# Consumer Knitex Limited. (Unit-2)- New Buildings

Baghan Trishal, Mymensingh 2222  
(24.552171N, 90.400753E)

19<sup>th</sup> November 2017

# Observation

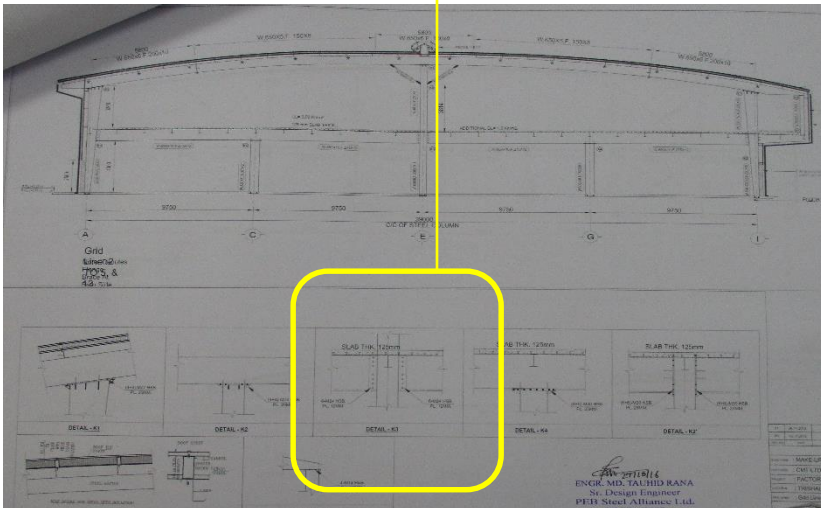
Additional short column in gable frame was not shown in drawing

Additional joints in rafter were not shown in drawing

Additional columns for cargo lift and toilet zone were not shown in column layout. Also thickness of flange was measured 6mm but in column section it shows 8mm.

| Item No. | Observation                                                             | Recommended Action Plan                                                                                                                         | Recommended Timeline |
|----------|-------------------------------------------------------------------------|-------------------------------------------------------------------------------------------------------------------------------------------------|----------------------|
| 1        | All buildings -<br>Paucity of details in As-Built drawings              | Building Engineer to survey as-built structure and prepare accurate as-built survey information with connection details for the building.       | 6-weeks              |

Section & connection details

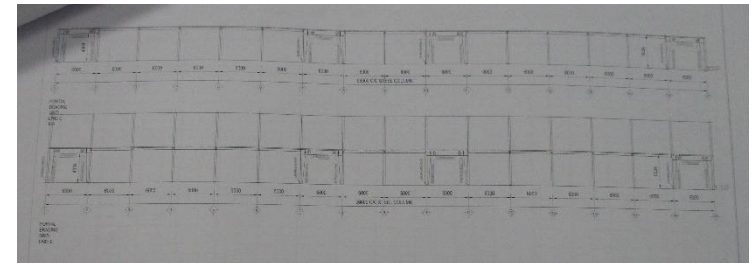
Connection details were not matched with provided drawings

Portal bracing layout

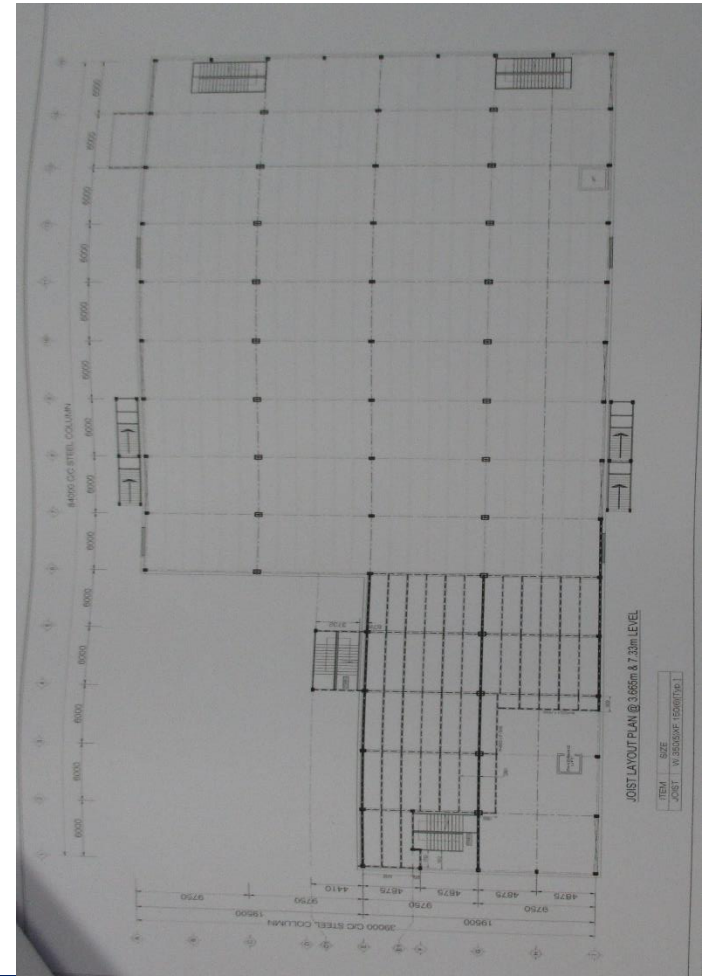
Cross bracing was observed instead of portal frame bracing

Connection Bridge

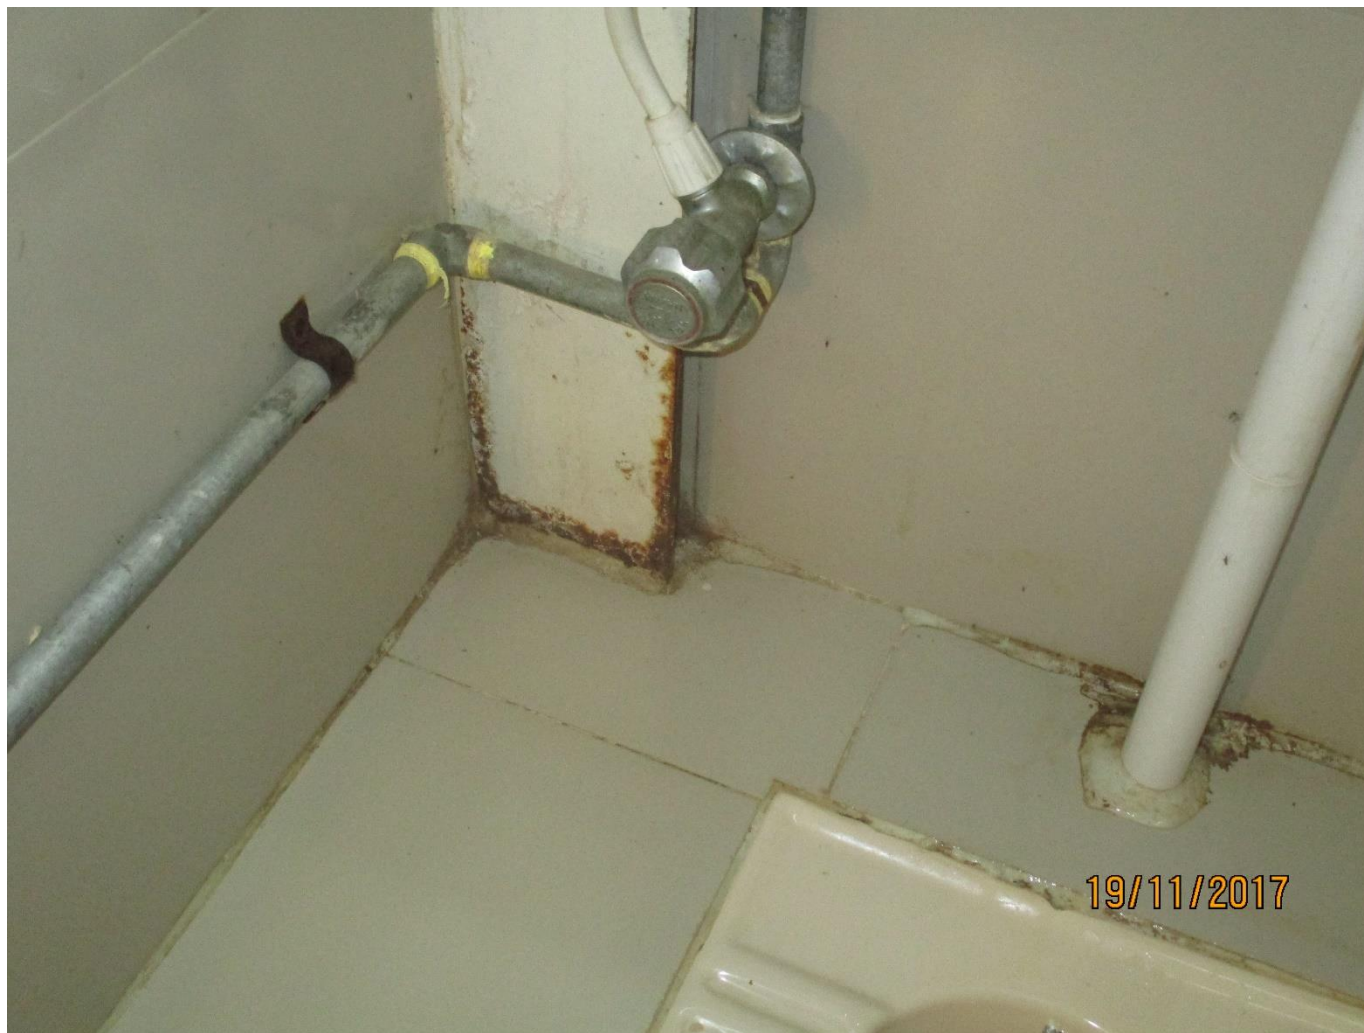
During inspection no drawings details were available for the connection bridge & Pump house.

| Item No. | Observation                                                             | Recommended Action Plan                                                                                                                         | Recommended Timeline |
|----------|-------------------------------------------------------------------------|-------------------------------------------------------------------------------------------------------------------------------------------------|----------------------|
| 2        | All buildings -<br>Lack of documents for connection bridge & pump house | Prepare up-to-date as-built documentation for all connection bridge & pump house.                                                               | 6-weeks              |
